*Errata*

*Manual: 14003*

*Manual Index: 0311*

**Figure 4.1.0.1: Main Board Connector Overview**

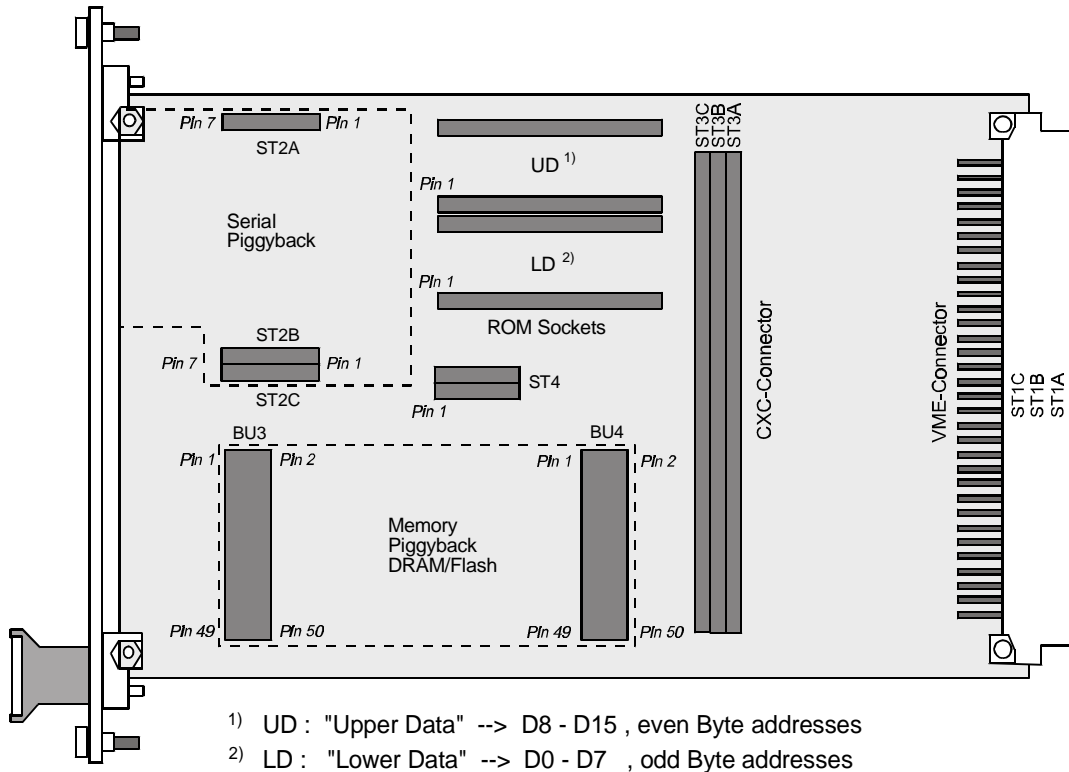
The referenced information (figure) is superceded by the following replacement figure. The replacement figure revises the CXC-Connector identifiers.
